MaxLatency Contribution

Contribution to IEEE 802.1Qdj

Astrit Ademaj, Juergen Wohlmuth

December 14, 2020

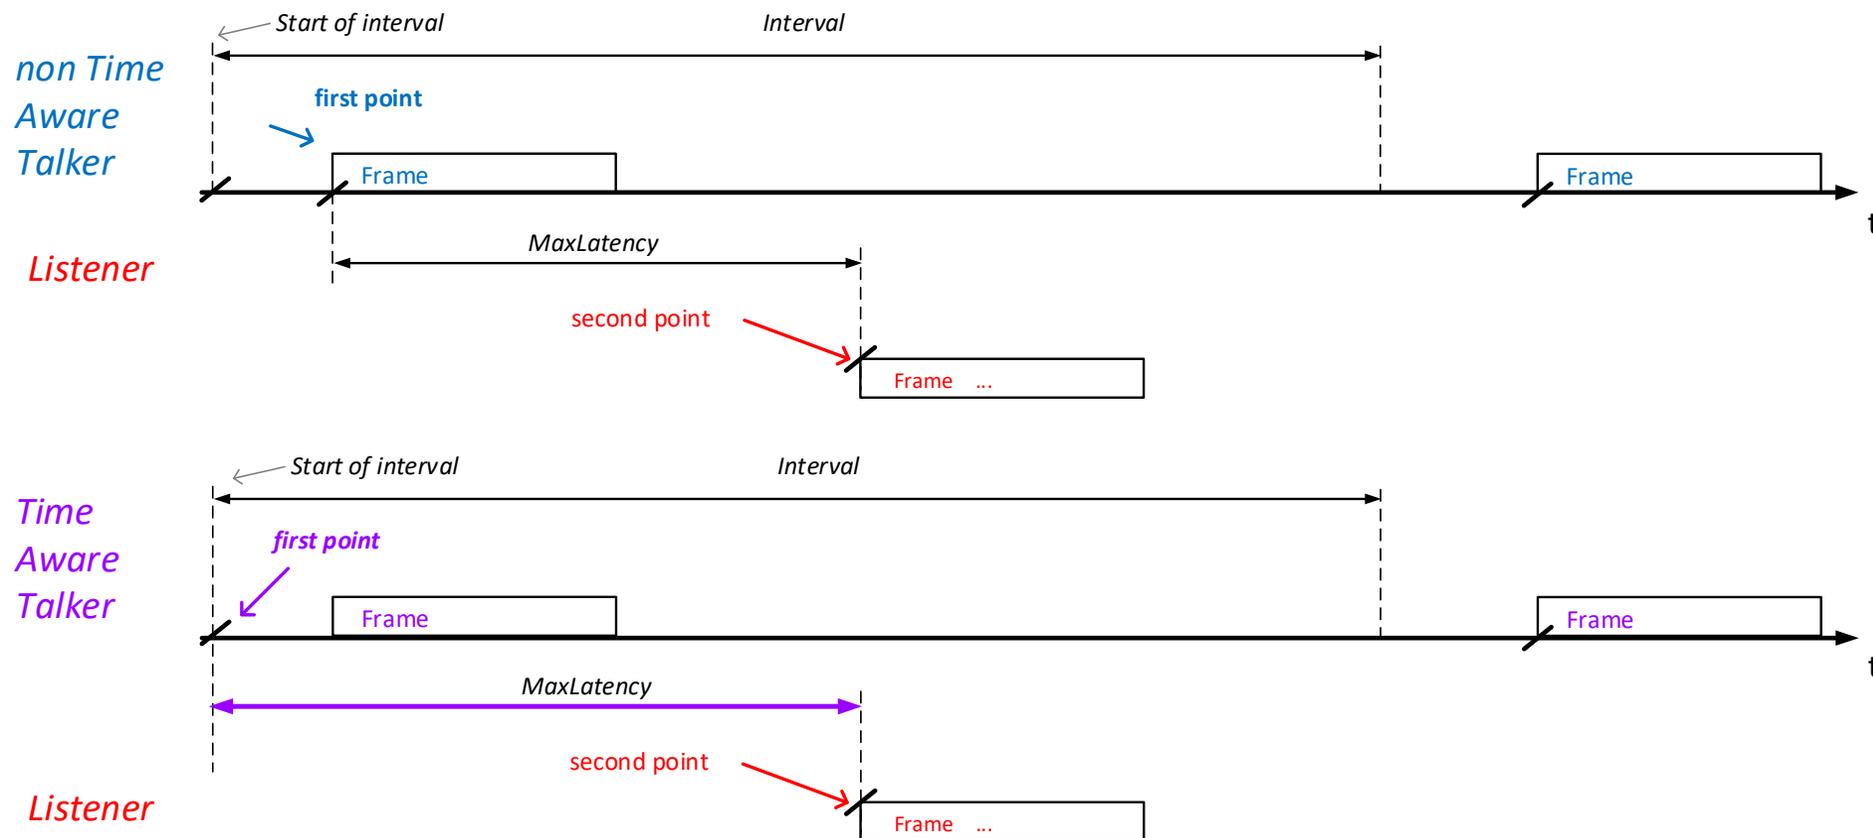
MaxLatency
definition becomes
a “deadline”
semantics for a time
aware talker

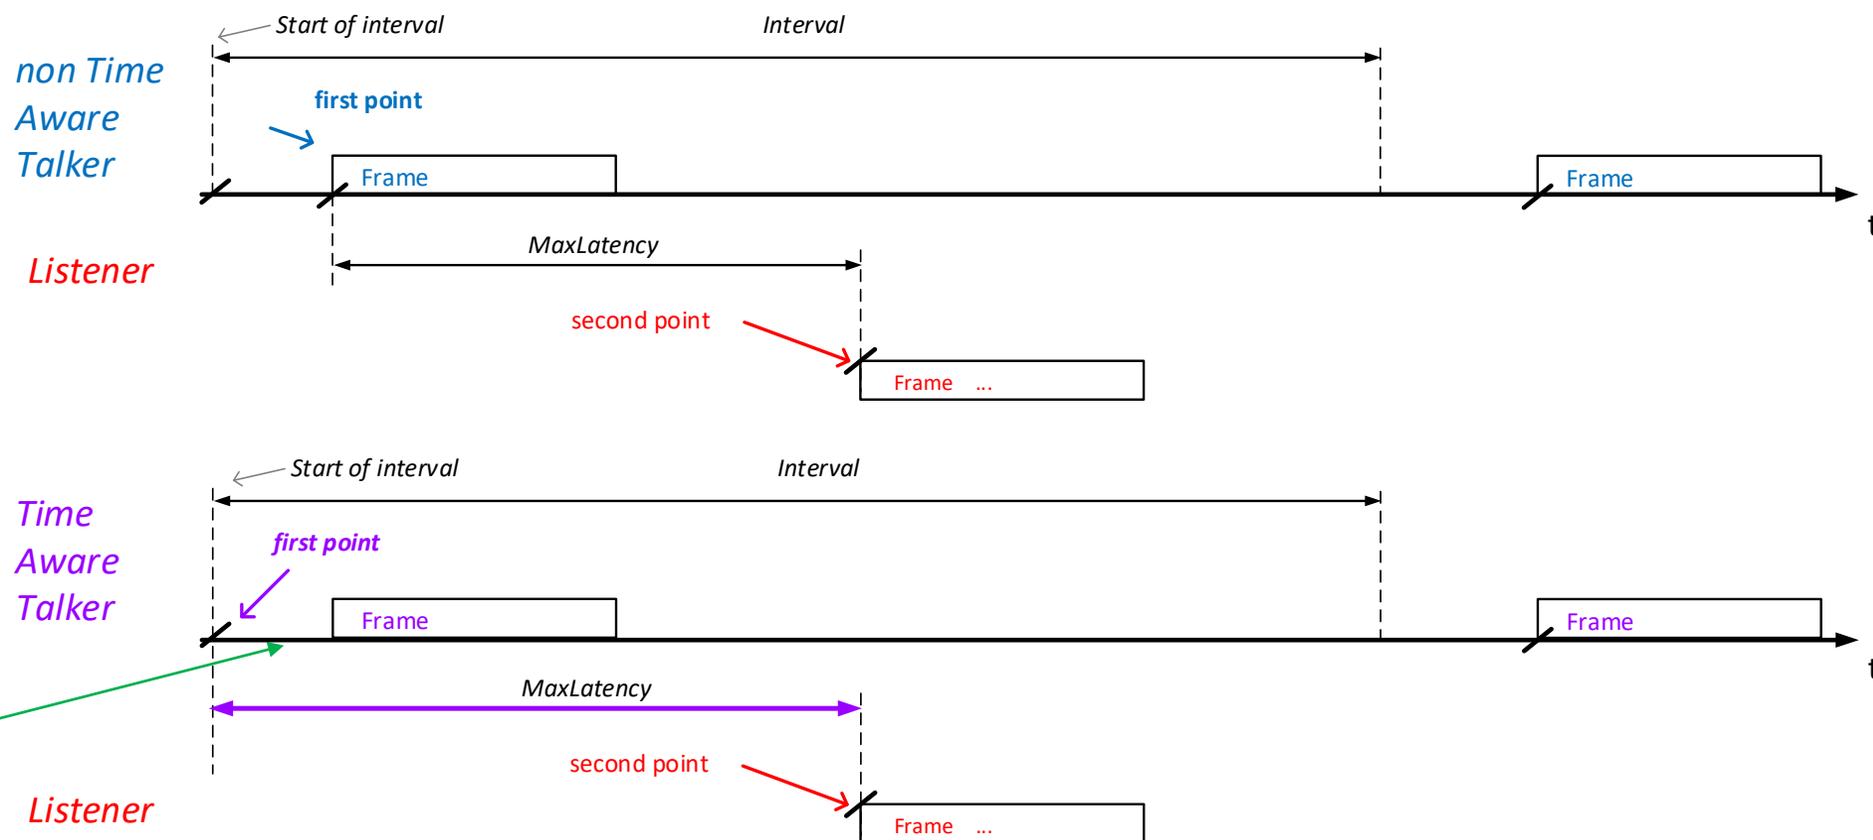
There are time intervals where the frame is not in propagation at all

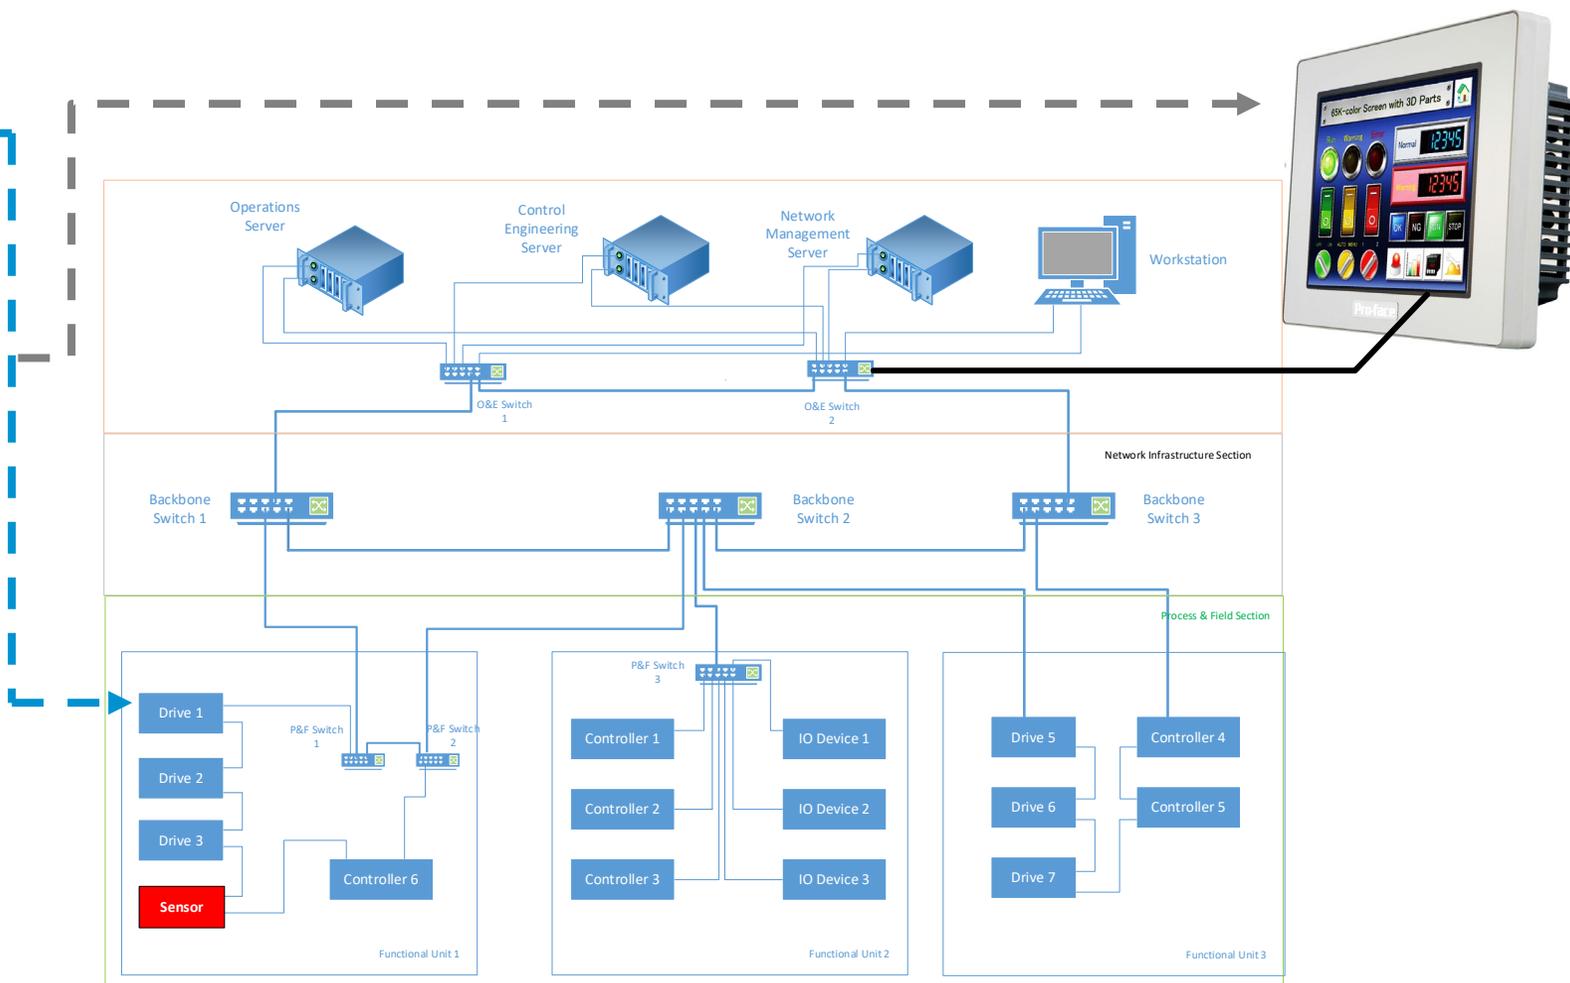
- MaxLatency is the “relation” between a talker and one listener
- In a single Network there may be different MaxLatency values (one for each listener)
 - some listeners may have “tight” latency for the same stream
 - e.g. Drive 1 receiving data from the red Sensor
 - other listeners may have very relaxed ones or not at all
 - e.g., a monitoring HMI device

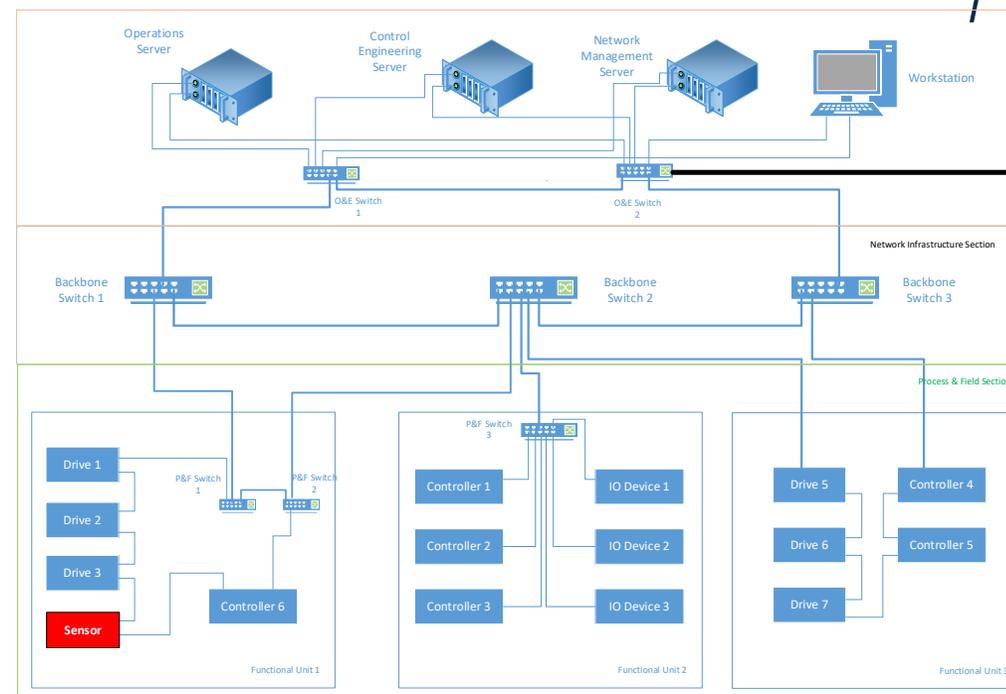
- In the CNC-CUC UNI there is a MaxLatency for each listener
- MaxLatency can be specified at the talker (35.2.2.10.7). In that case the MaxLatency applies to all listeners
- The only use case in industrial where the MaxLatency makes sense is if it represents the validity of the data send with this stream
 - however, this is an application-level semantics and shall not be represented in the
- In some use cases setting the latency requirements at the talker may cause conflicts with the “fare away” listeners, specially in the case of converged networks
 - If the MaxLatency at the talker is set higher - that would invalidate the MaxLatency requirement for the listeners
 - If the MaxLatency at the talker is set lower - that would lead to some listeners not being able to receive the stream

Proposal 3: Remove the latency requirement at the talker
